Technical Newsletter

No:  
39

Subject:  
Incorrect SMART motor protection 51 511 00-04

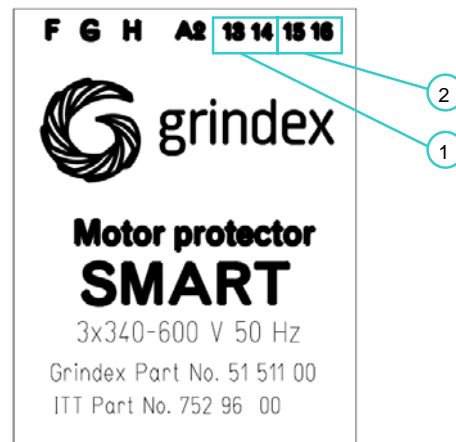
We have discovered a defect in our SMART motor protection with part number 51 511 00 up to 51 511 04. The function for connection 13-14 is mixed up with connection 15-16.

- **13-14 has by mistake automatic restart instead of manual reset**
- **15-16 has by mistake manual reset instead of automatic restart**

1. **13-14**, input for overload relay (only Master and Matador) with **manual reset**. If the overload relay trips, the power to the pump must be disconnected and connected before the pump can start.
2. **15-16**, input for thermal contact from stator with **automatic restart**. If the thermal contact trips caused by high temperature, the pump will automatic restart when it has cooled down.

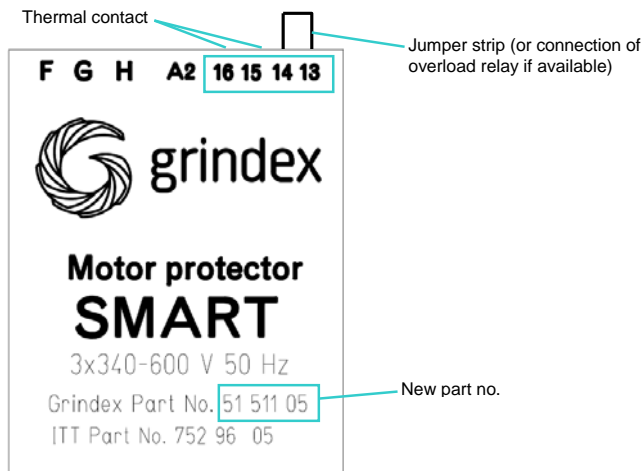
- All pumps in Grindex production and spare parts stock was remarked and reconnected (see example below) from date 2011-09-20.
- Wrong marked SMART (part number 51 511 00-04) replaced by new part numbers, see list under *Spare parts*.
- Remarking and reconnecting of motor protections, all distributor's:
  - Spare parts 51 511 00-04 in stock (only remarking with sticker)
  - New pumps in stock (remarking and reconnecting)
  - Pumps coming in for service (remarking and reconnecting)

Stickers with changed marking for 13-14 and 15-16 and new part number (see example below) will be sent out to each distributor.
